Access Compliance Report

Public Rights-of-Way

Intersection ID: 31906	Main Street: LAMOILLE_LN	Cross Street: PALOMAR_MOUNTAIN_DR	Location: SE
ADA ID: 962A8A99F7EA	Ramp Type: PerpDiag	Initial Pass/Fail: Fail	Overall Compliance: No
		Severity Score: 8.75

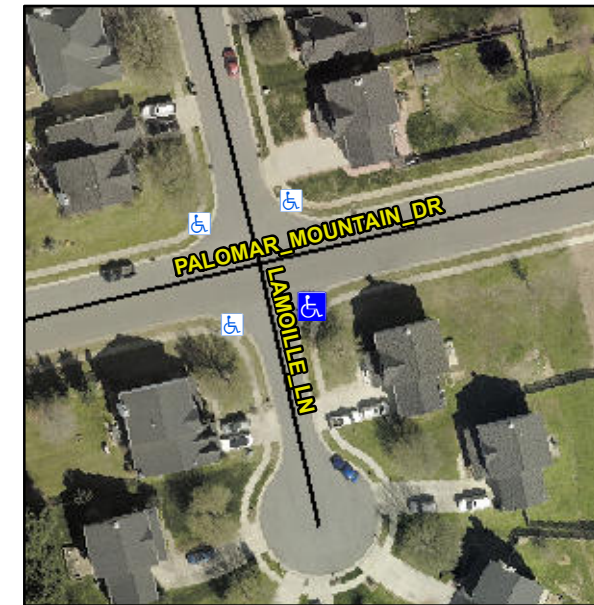
R304.5.1

Compliance	Description	Data	Compliance	Description	Data
N/A	Ramp Length (in)	48.0	Yes	Ramp Slope (%)	5.3
No	Ramp Width (in)	46.0	Yes	Ramp XSlope (%)	2.0
N/A	Flare Type LT	N/A	N/A	Flare Type RT	N/A
N/A	Flare Slope LT (%)	N/A	N/A	Flare Slope RT (%)	N/A
N/A	Flare Traversable LT?	N/A	N/A	Flare Traversable RT?	N/A
N/A	Landing Length (in)	N/A	N/A	DWS Provided?	N/A
N/A	Landing Width (in)	N/A	N/A	DWS Contrast?	N/A
N/A	Landing Slope (%)	N/A	N/A	DWS Length (in)	N/A
N/A	Landing X Slope (%)	N/A	N/A	DWS Full Width?	N/A
N/A	Landing Curb? (Y/N)	N/A	N/A	DWS Offset (in)	N/A
N/A	Shared Landing?	N/A			
N/A	Gutter Ponding?	N/A	N/A	Gutter Slope (%)	N/A
N/A	Gutter Lip Ht (in)	N/A	N/A	Gutter X Slope (%)	N/A
N/A	Painted X Walk1?	No	N/A	Painted X Walk2?	No
	X Walk 1 Direction	To N		X Walk 2 Direction	To W
N/A	X Walk 1 Width (in)	N/A	N/A	X Walk 2 Width (in)	N/A
	X Walk 1 Slope (%)	1.0		X Walk 2 Slope (%)	0.8
	X Walk 1 X Slope (%)	1.2		X Walk 2 X Slope (%)	0.2

Remove & Replace Curb Ramp With Two New Directional Ramps or Equivalent.
